Re: Northwest Self Storage

Completeness Response for CUP-16-01 et al. Project Number 2150120.01

## RESPONSE TO PLANNING DEPARTMENT COMMENTS

SL1.0

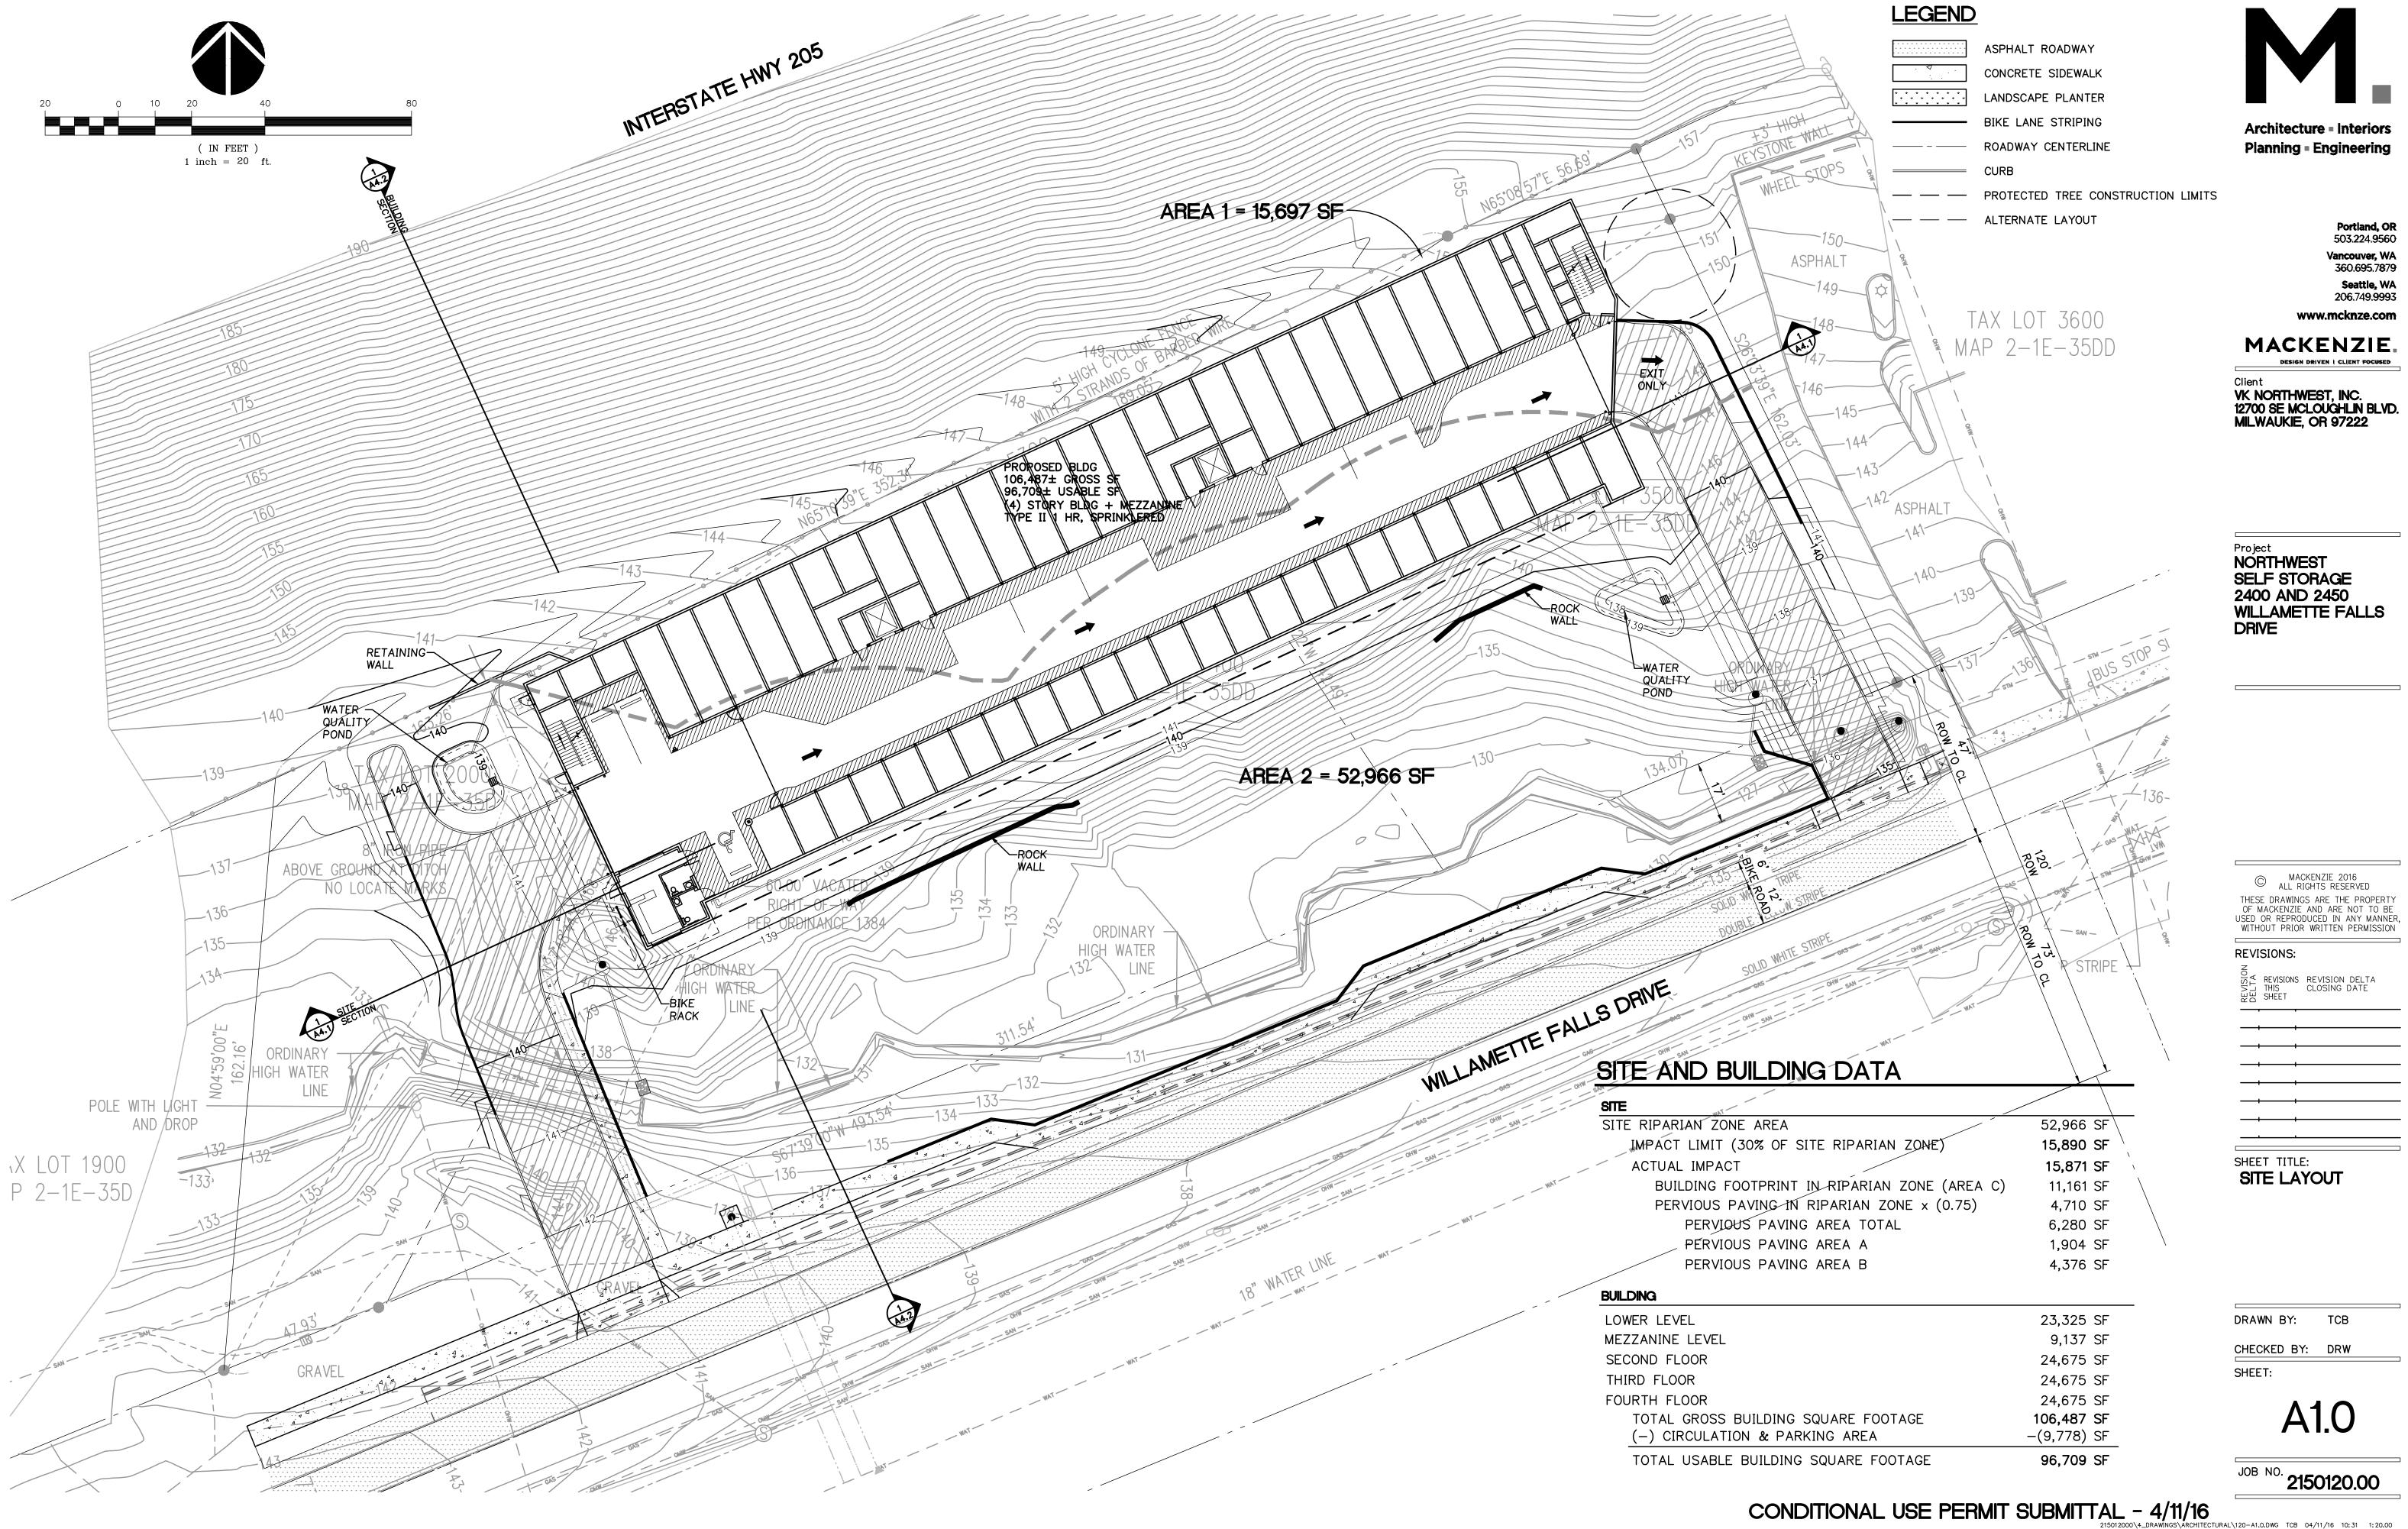
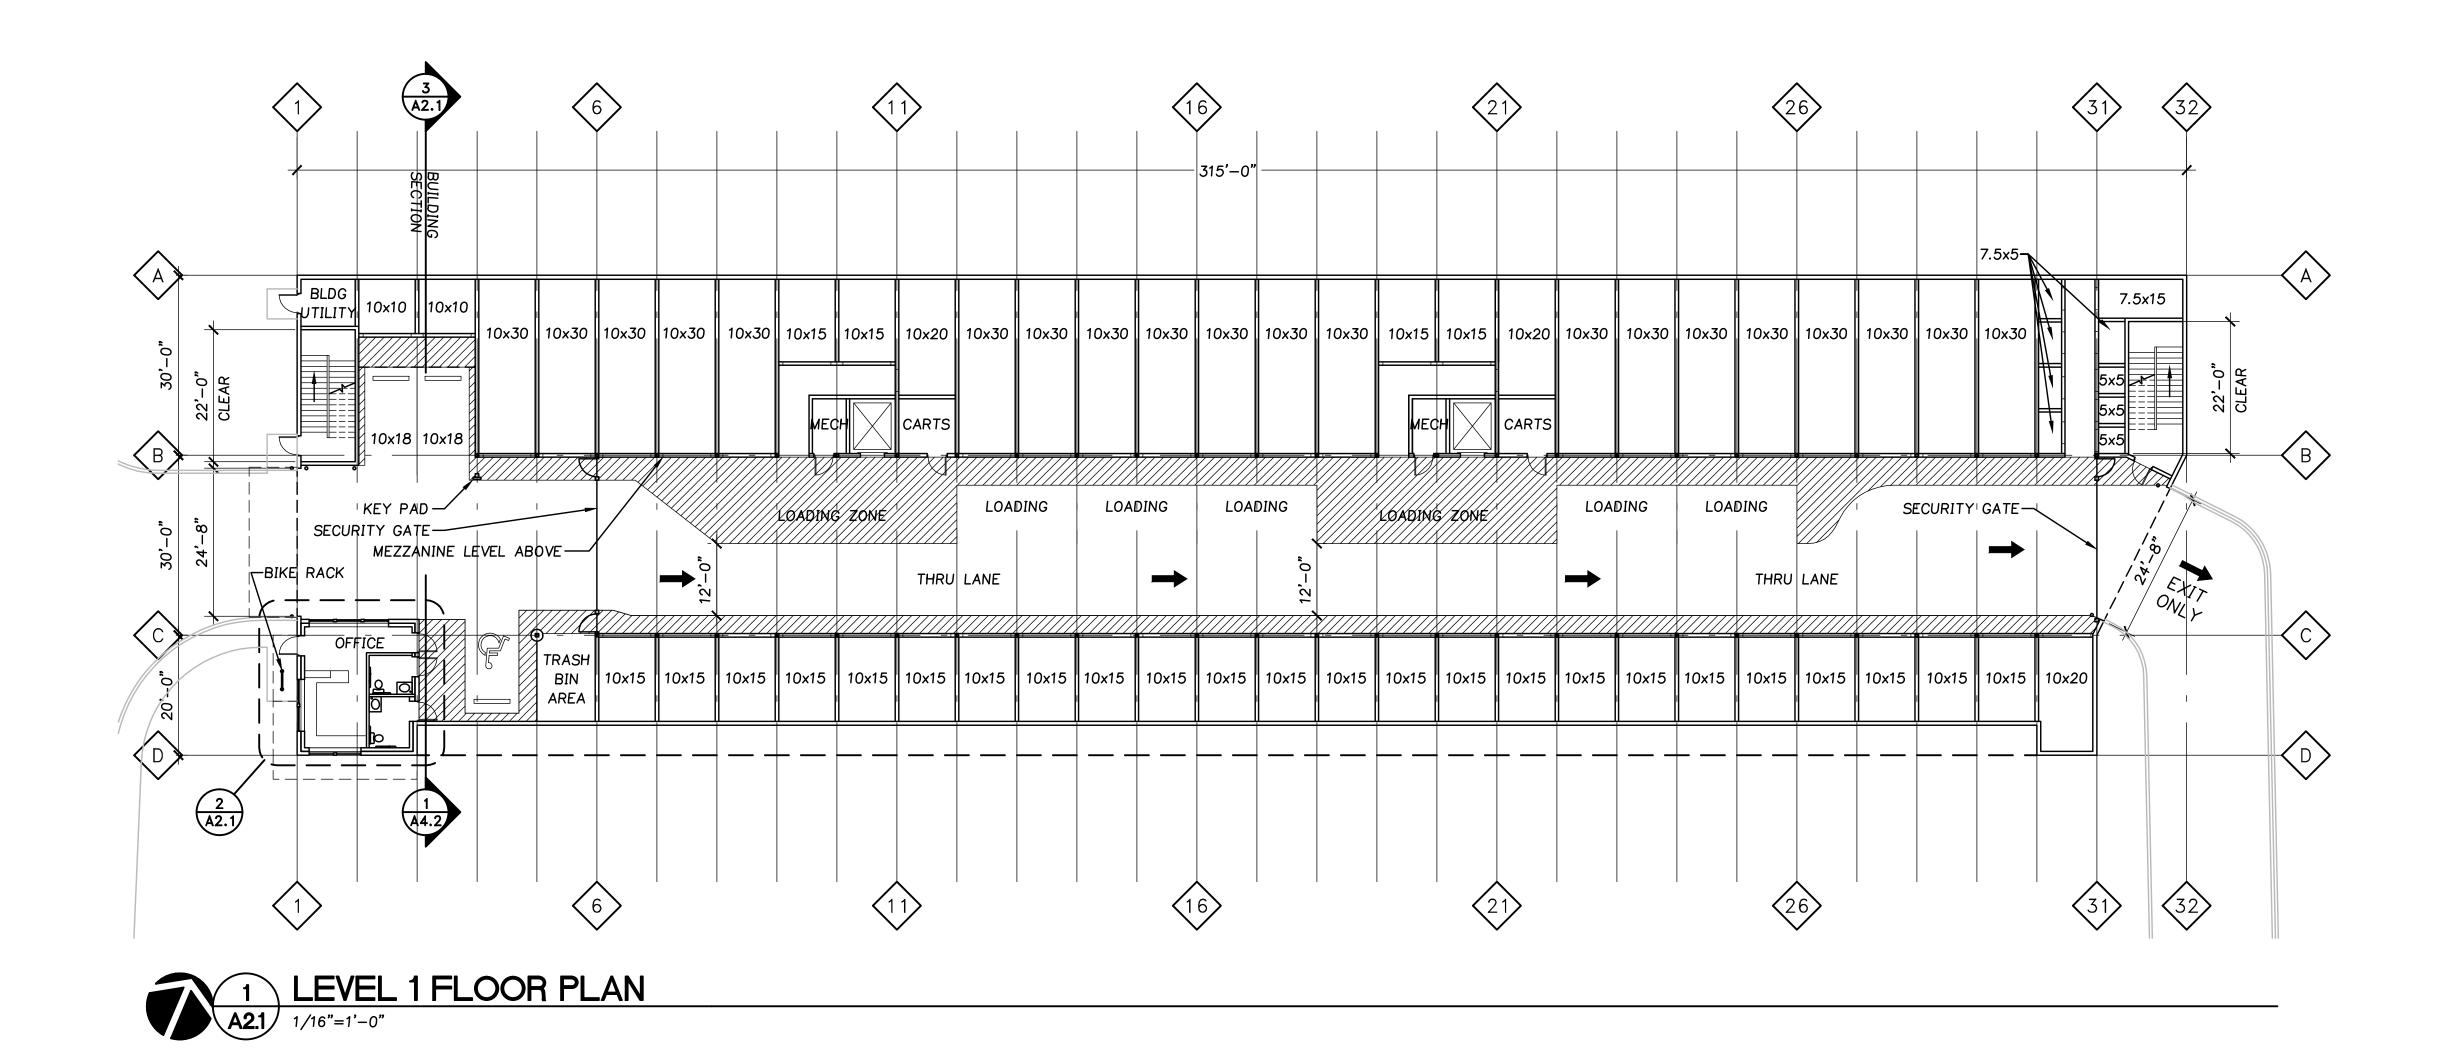
55.100(J) (6) and 55.100(D) (3). In order to address this criteria (no off-site glare especially as seen from homes across the street) an illumination/lighting plan is needed to locate all light fixtures and the levels of illumination on the site.

**Response:** We have included a site illumination plan with the revised submittal to illustrate the lighting levels. The number of light fixtures will be limited to the minimum necessary to comply with standards requiring lighting to be directed away from residences, streets, and the WRA.

#### Figure 3 - Habitat **Conservation Areas (HCAs) NW Self Storage** West Linn, Oregon

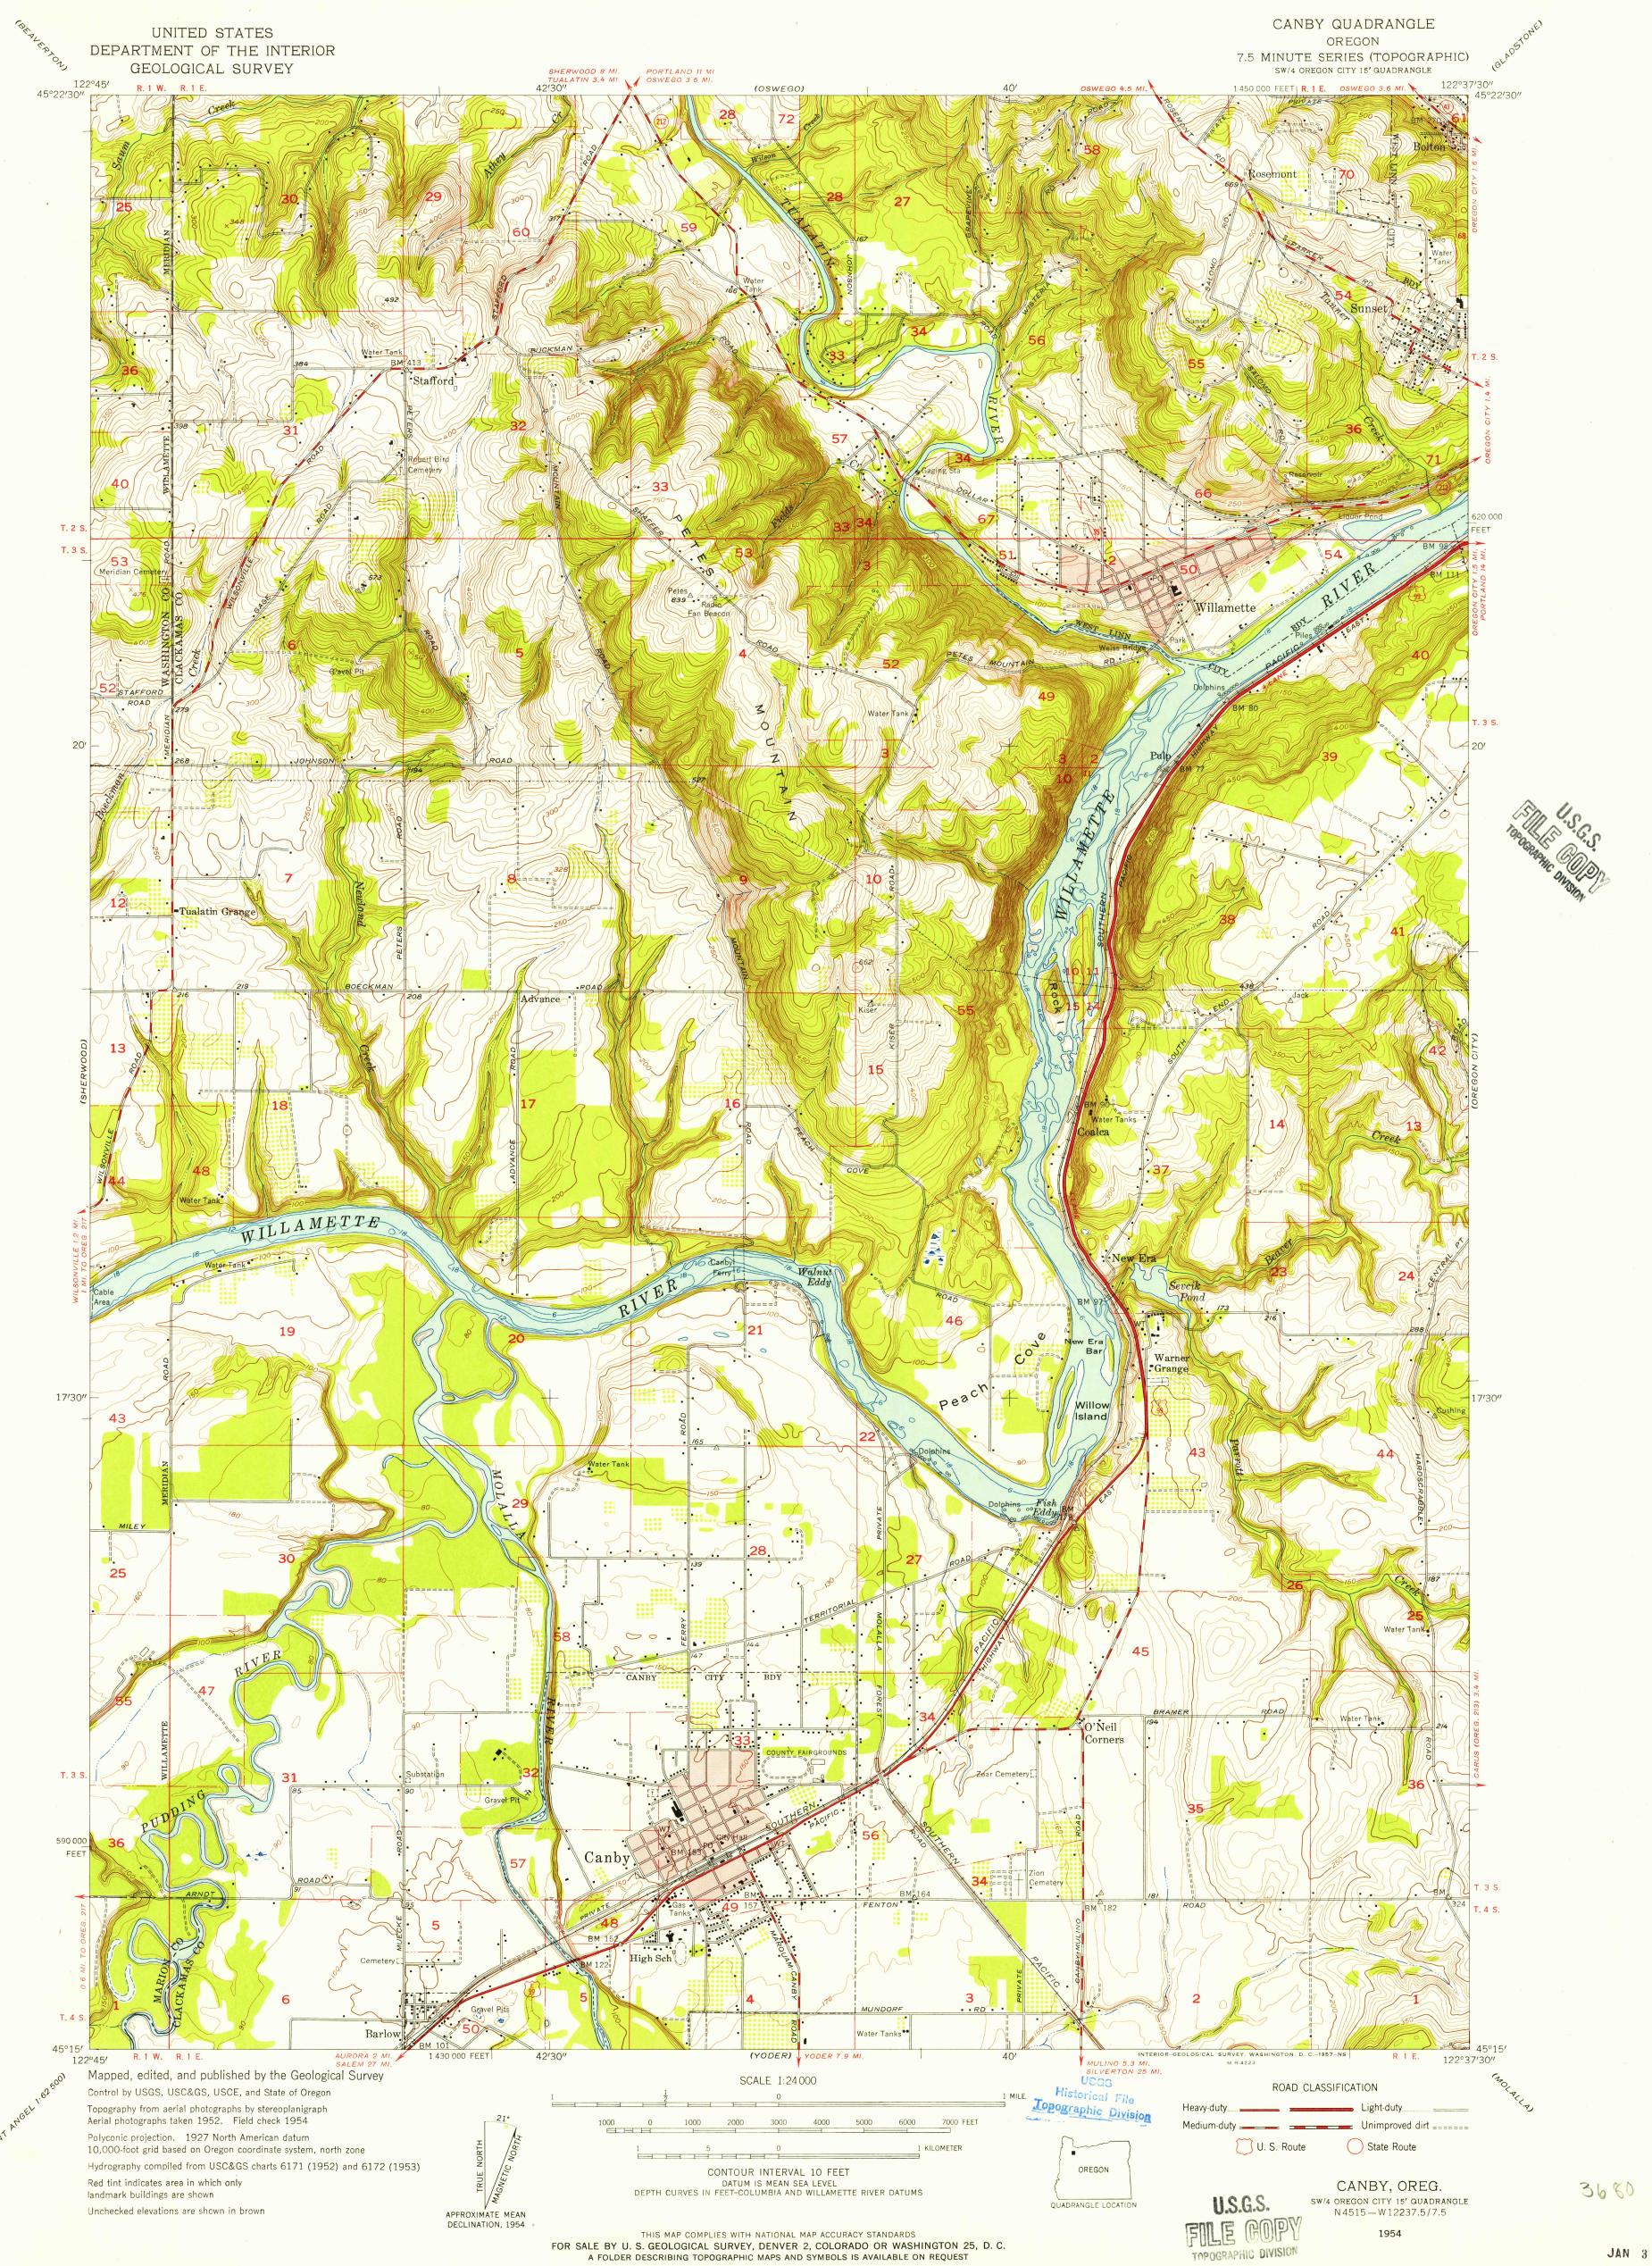
28.090(C) (2) and 28.120(B) (10) and 55.120(B) (7) (d). Map HCA boundaries by low, medium and high designations to replace Figure 3 map (Willamette and Tualatin River Protection Area permit application) submitted with "Riparian Wildlife Habitat Class I and II" designations.

**Response:** The HCA initially submitted with our May 2 letter regarding findings for a Willamette and Tualatin River Protection Area Permit has been revised per the nomenclature above. The map is now included in Exhibit I in the revised narrative.
